PARK CENTRAL AT INTERPARK  
PRELIMINARY OVERALL AREA DEVELOPMENT PLAN  
P.O.A.D.P. No. 160

Re: Park Center at Interpark  
Plan #160

Re: Park Center At Interpark  Preliminary Plan  
 P.O.A.D.P.  
File #: 85-16-62-28

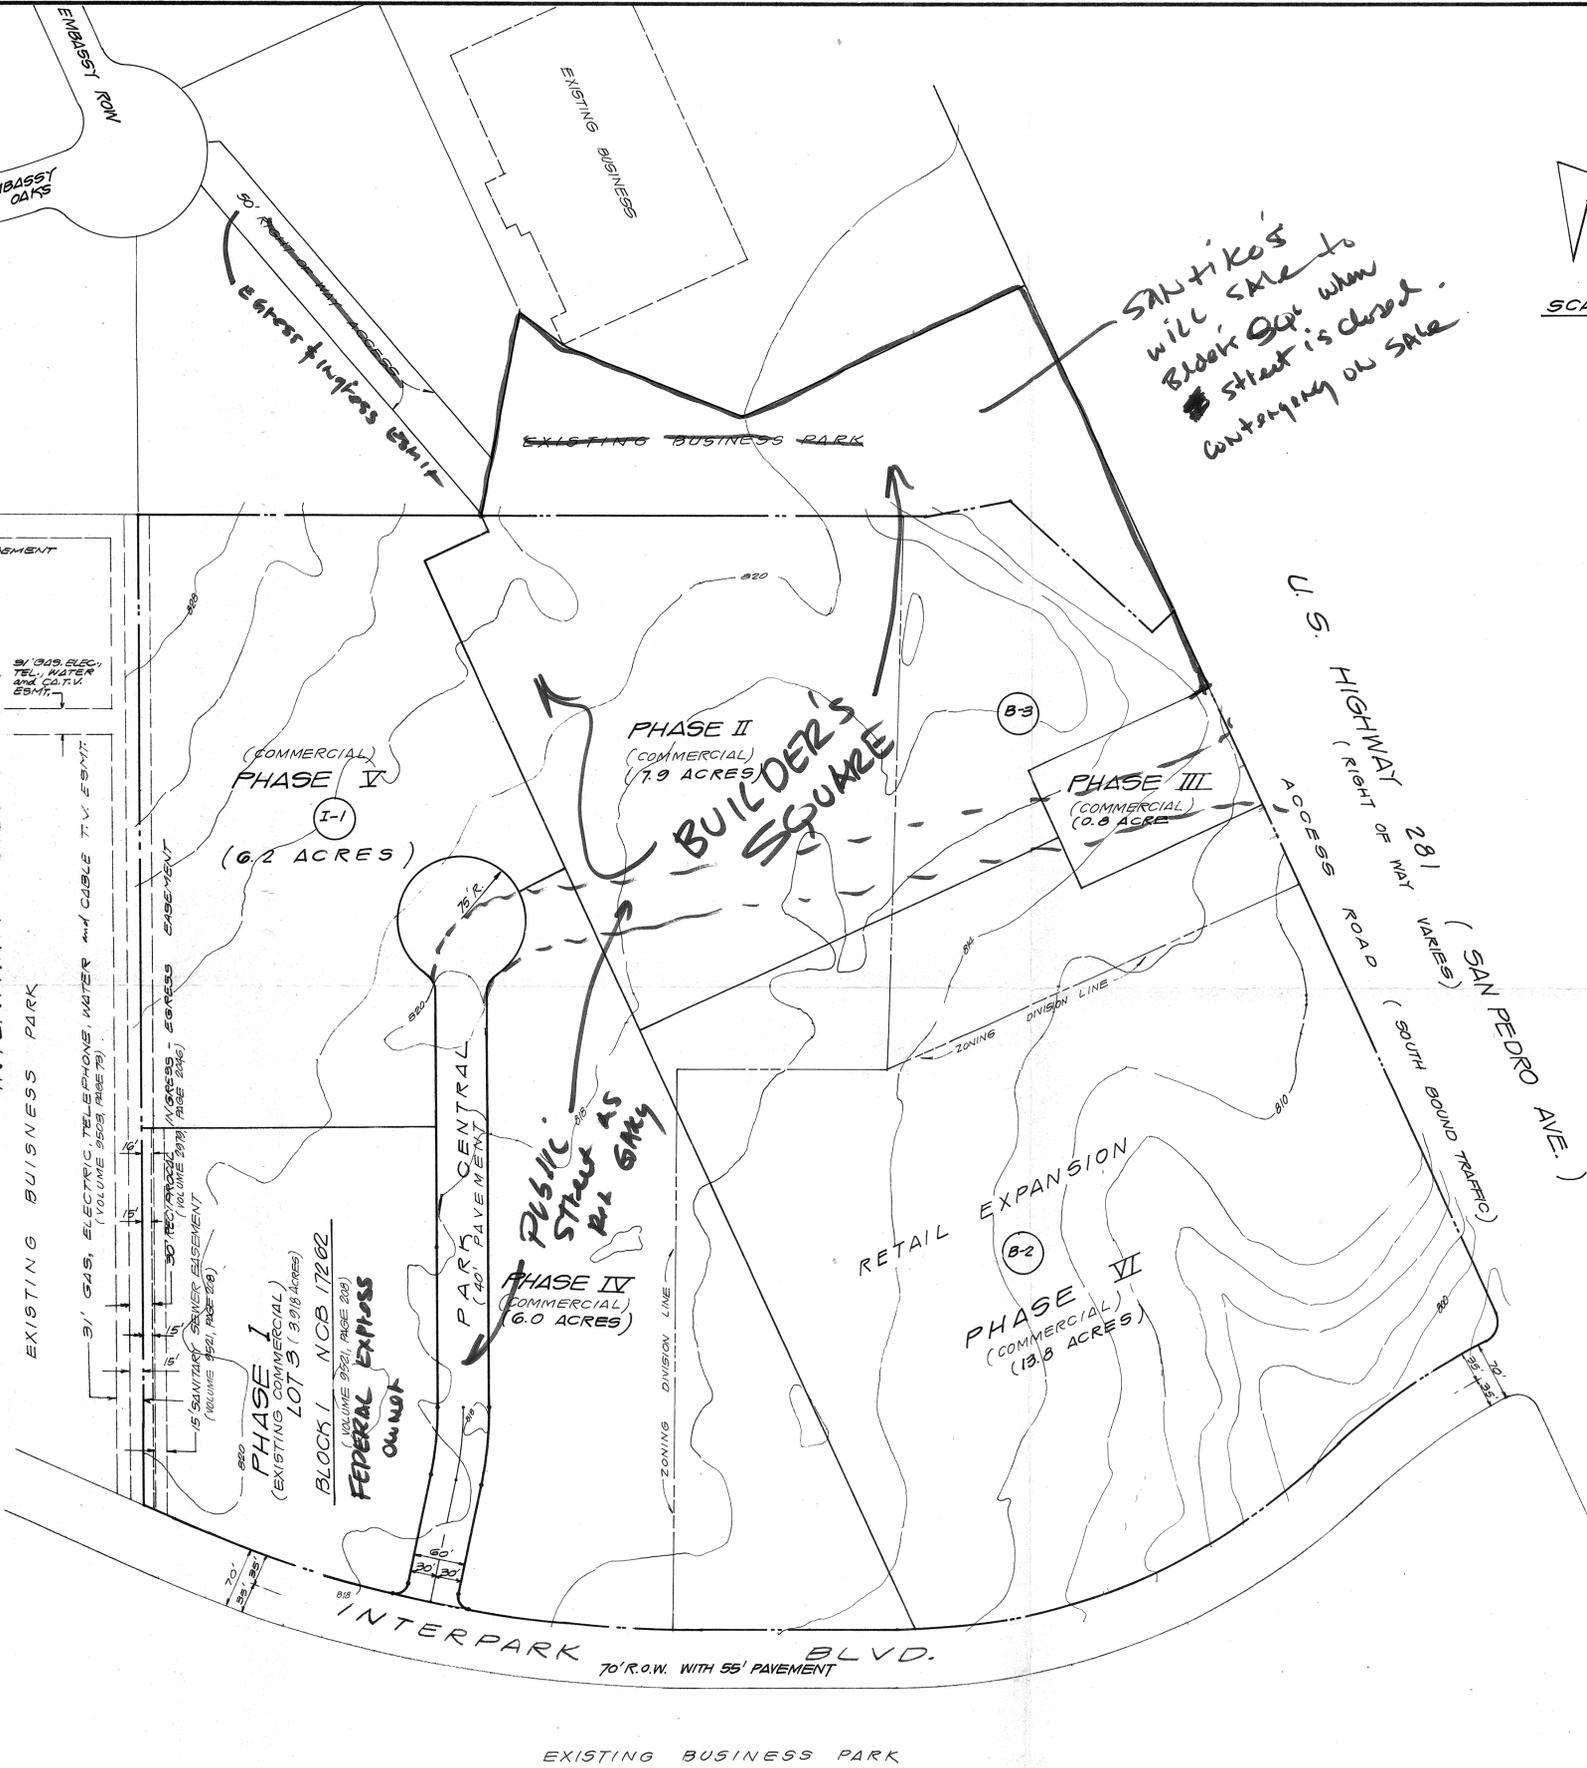
SANTIAGO'S  
will sale to  
Bloor Co. when  
street is closed.  
contingency on sale.

Eng. has submitted a request to Bill TOUDOUZE to close & quitclaim a portion of Park Central with processing fee. Also, the Federal Express signed a contract with Transal Chow prior to purchase of their property acknowledging future closure of the ROW. Mendoza from Real Estate, is waiting for a letter from the Federal Express Office to confirm that they offer no objection to the street closure.  
The Eng. will review the plan and resubmit on Monday 6/21/91.

P.S. also asked the engineer to submit a summary letter explaining the situation.

R.R.  
6/21/91.
